**ADDENDUM NO. 2 – DPW#17603 – Southeast Idaho Veterans Cemetery**

**Project:** DPW#17603 Southeast Idaho Veterans Cemetery  
Blackfoot, Idaho

**DPW Project No:** 17603  
**VCGP Project No:** FAI ID-13-03

### Architectural Addendum No 02

DETAIL: PER VA PROGRAM –  
ENTRY ROOF/ADMIN BLG.

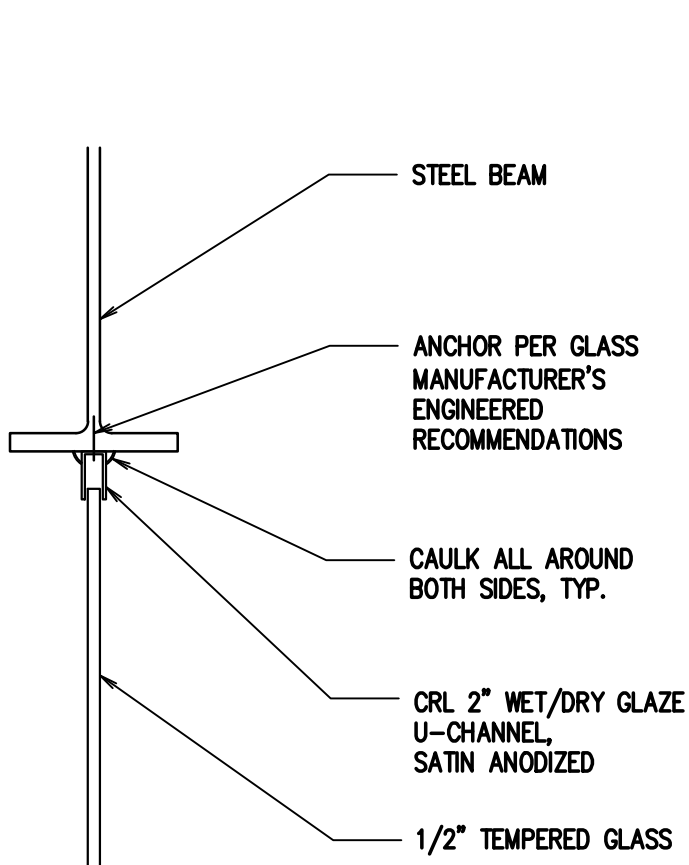
AD2.7 Administration Building: Per VA Program – Entry Roof

Delete Metal canopy.

Delete window 100B.

Add Roof structure similar to roof structure south of the vestibule of the Add Alternate.

DETAIL: PER VA PROGRAM AND  
 ADD ALTERNATE #03 - SHIP LADDER

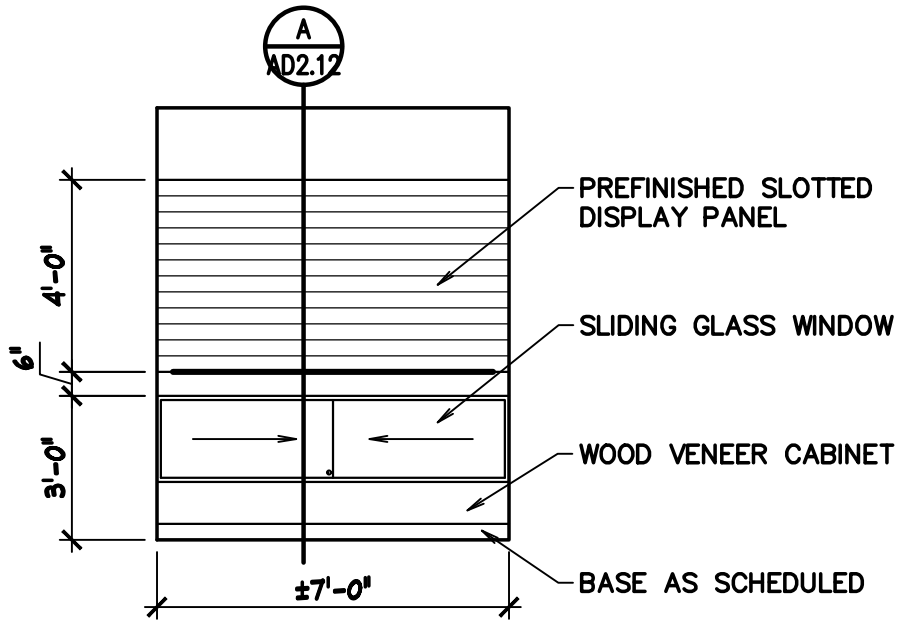
AD2.10 Maintenance Building: VA Program and Add Alternate #03 – Ship Ladder

Change riser height to 9 inches.

ADDENDUM #2 - PERIMETER TREES

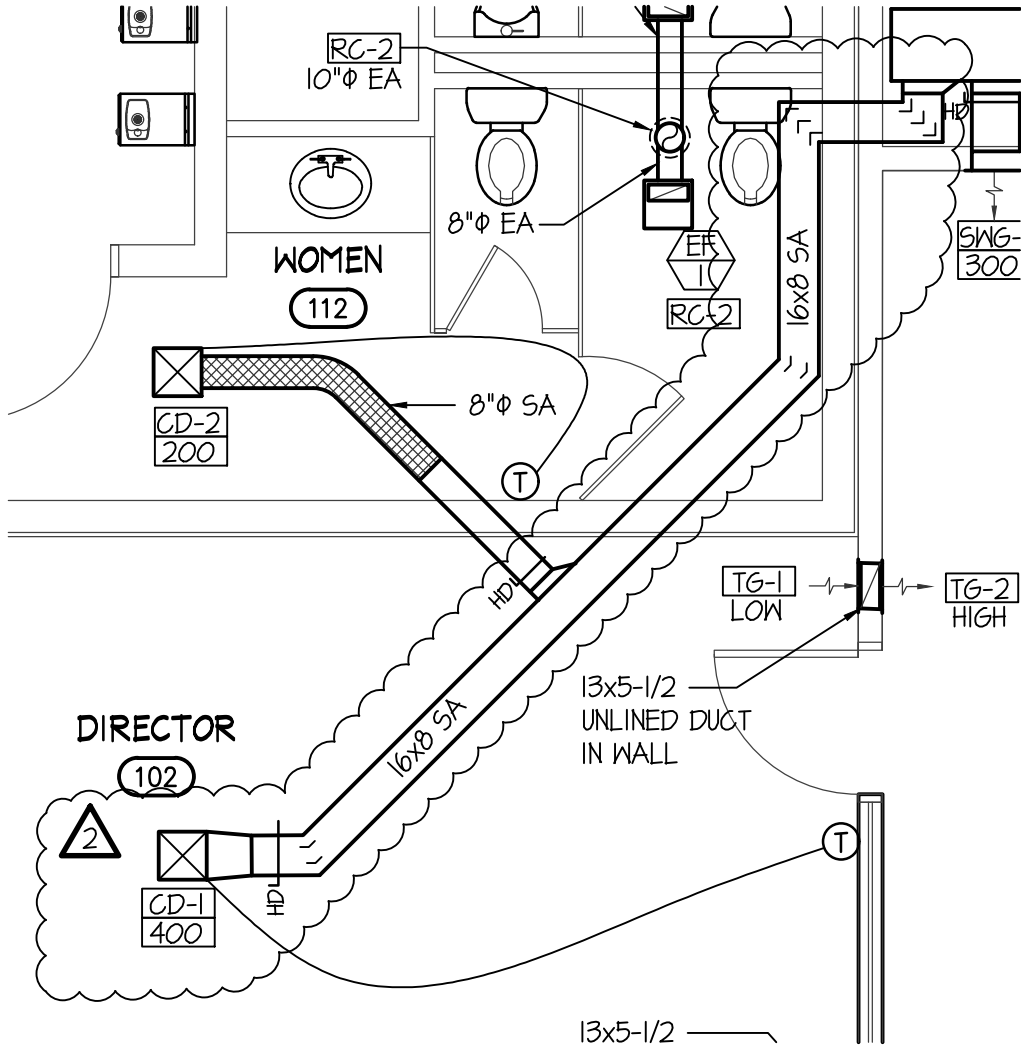
ADDENDUM #2 - PERIMETER TREES

DELETE PERIMETER TREES WITHIN SHADED AREA

2.0" CALIPER DECIDUOUS TREES = 25

1.5" CALIPER DECIDUOUS TREES = 66

5'-6' HEIGHT CONIFER TREES = 50

4'-5' HEIGHT CONIFER TREES = 65

**DETAIL:**  
WELLHOUSE BUILDING MECHANICAL PLAN

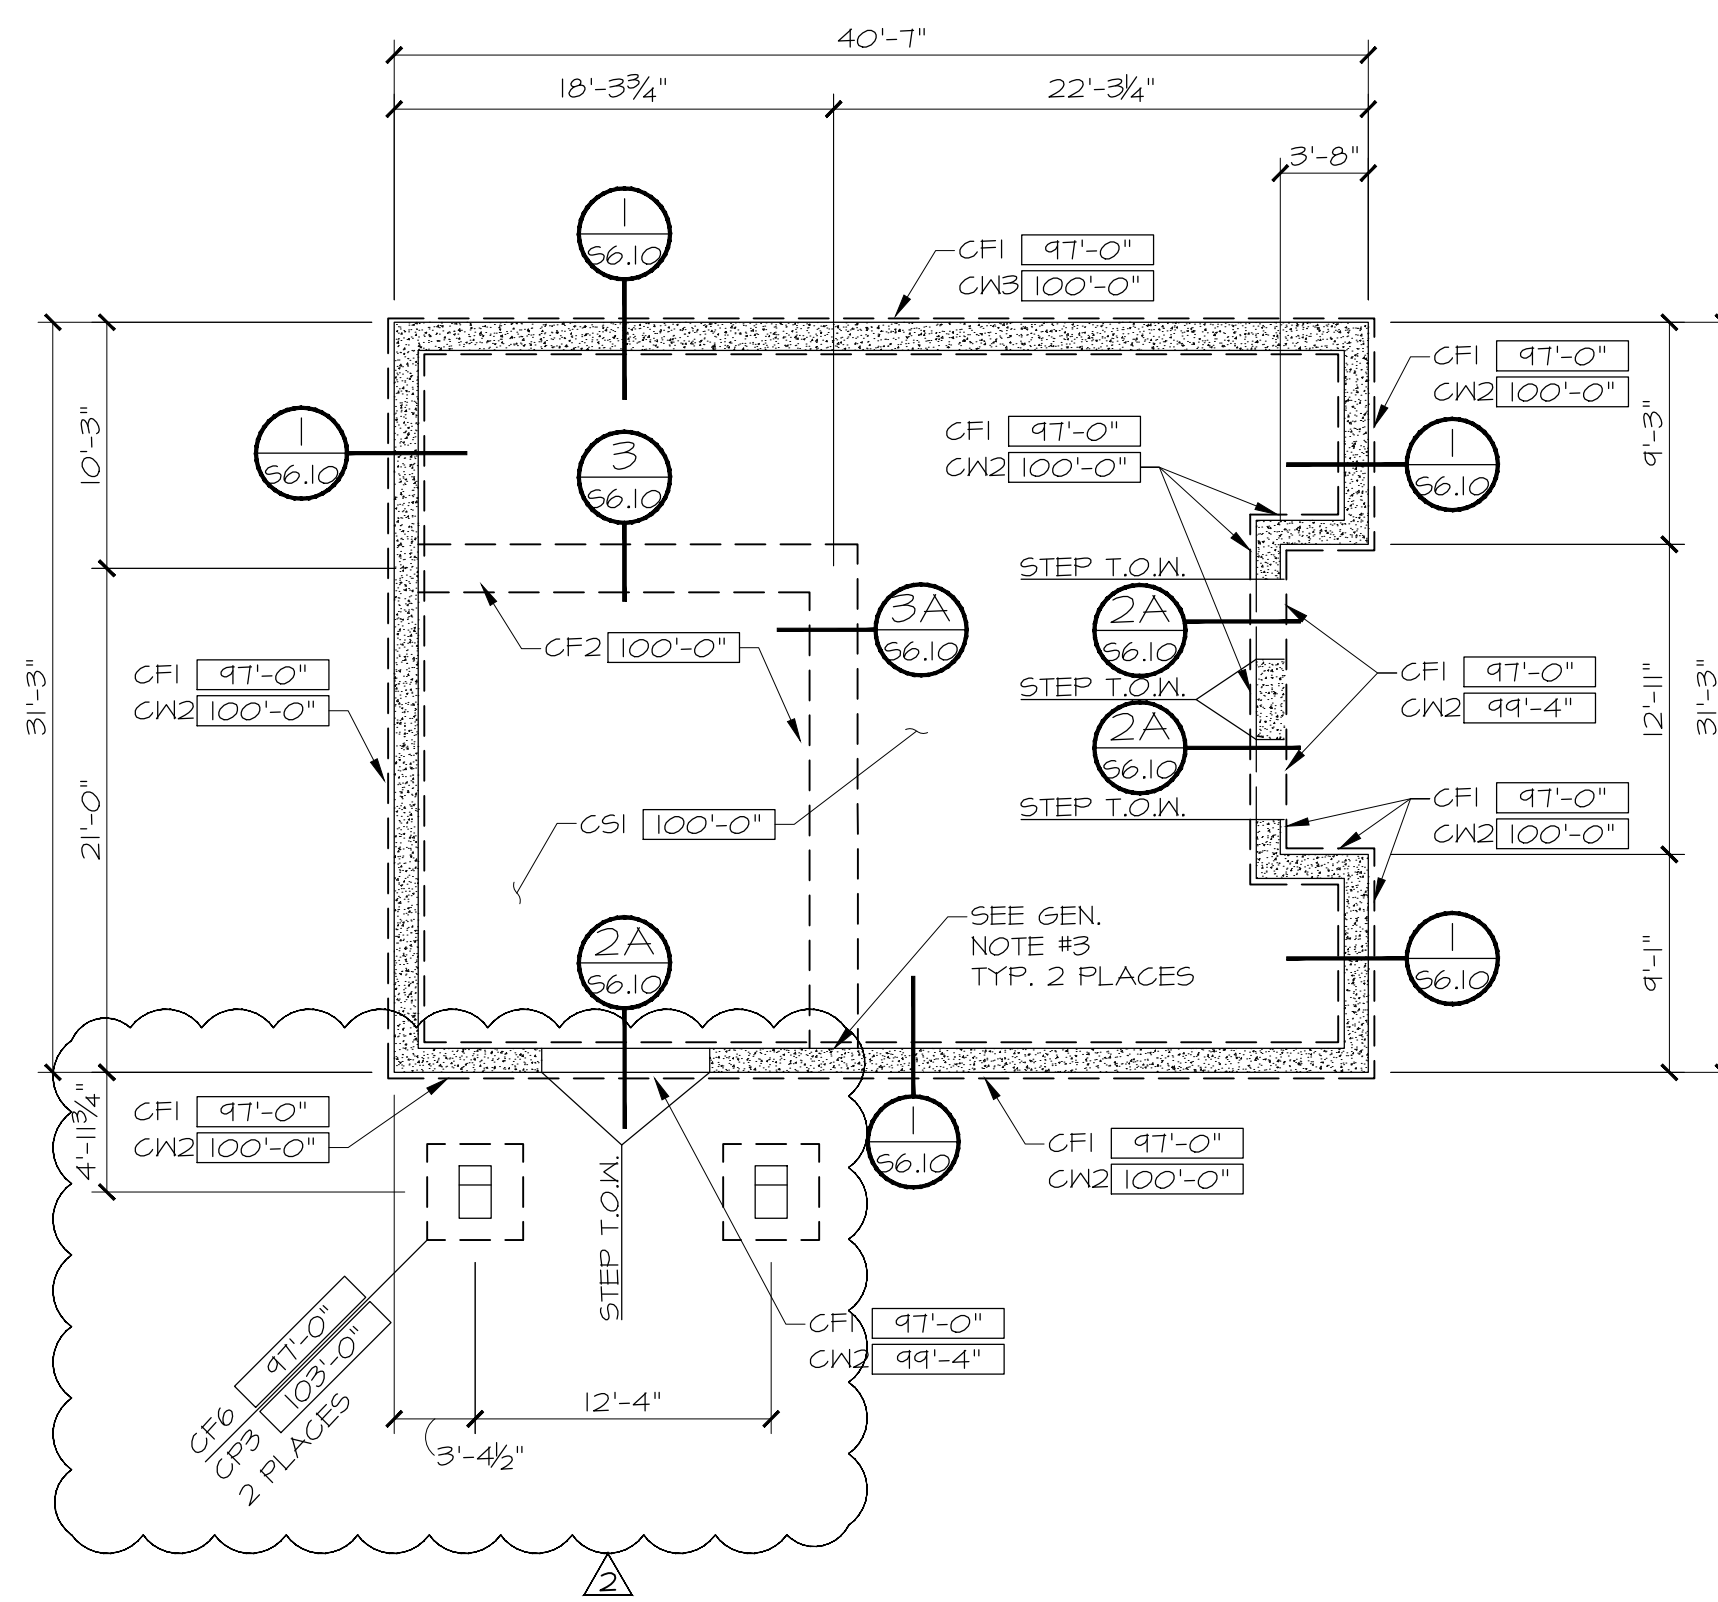
1. Add a circuit to the electric heater flush in wall, type EH-1. Refer to mechanical plans for location. Homerun to a 20A/2P circuit breaker in panelboard W.
2. Extend the 120 volt lighting circuit to ceiling exhaust fan EF-1. Install an empty outlet box at +44" adjacent to the light switch with 1/2" empty conduit up to the exhaust fan. This empty box is for a heat-rise thermostat installed by mechanical contractor.
